January 7, 2010

RE: *Application Review – Supplemental*  
Housatonic Railroad Company, Inc., Shepaug Terminal  
30 Hawleyville Road (Rt. 25), Newtown, Connecticut

*JMM Job # 09-1193-NWT-4*

**FIGURE 1a:** Site prior to tree clearing and filling showing Wetland Area 1

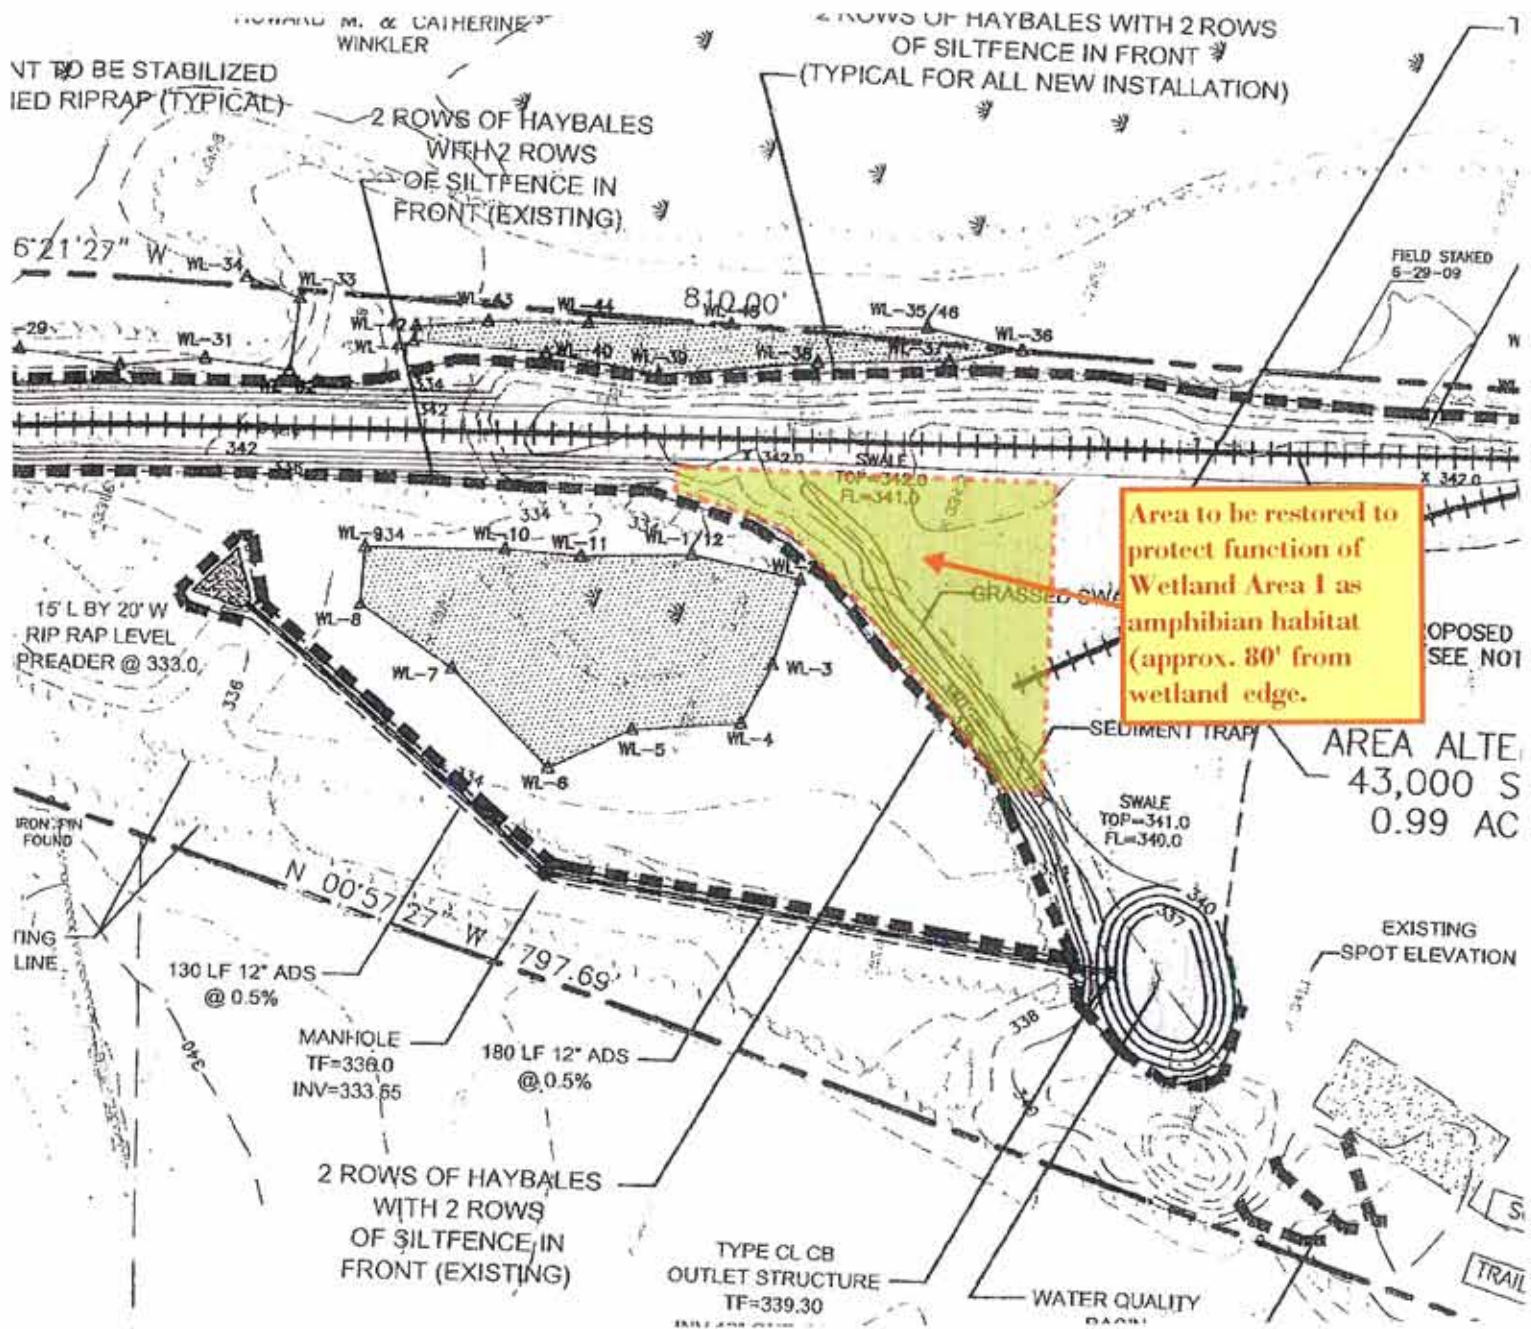
Both JMM and SSES agree that the north central wetland (i.e. Wetland Area 1) is a potential vernal pool habitat. We also both agree *“a review of the wetland area in the spring breeding period would confirm if the wetland is a productive vernal pool.”* However, we do not agree with SSES that the presence of tadpoles in the wetland after the recent clearing and placement of fill necessarily means that no significant impact upon the amphibian breeding population has occurred. In all likelihood the population has suffered and, therefore, restorative mitigation should be proposed.

Figure 1a, attached, shows the condition in the vicinity of Wetland Area 1 prior to any of the recent disturbance within the 100 foot Upland Review Area (URA). Figure 1b shows what, in our opinion, should be the minimum restorative mitigation to reclaim the function of this wetland as a productive amphibian breeding area. Should the wetland pool prove to also support obligate vernal pool species, such as wood frog, then the proposed mitigation might have to be expanded to 100 feet, which is the minimum protection envisioned by experts in the field of vernal pool ecology and protection (e.g. Calhoun and Klemens 2002)<sup>1</sup>.
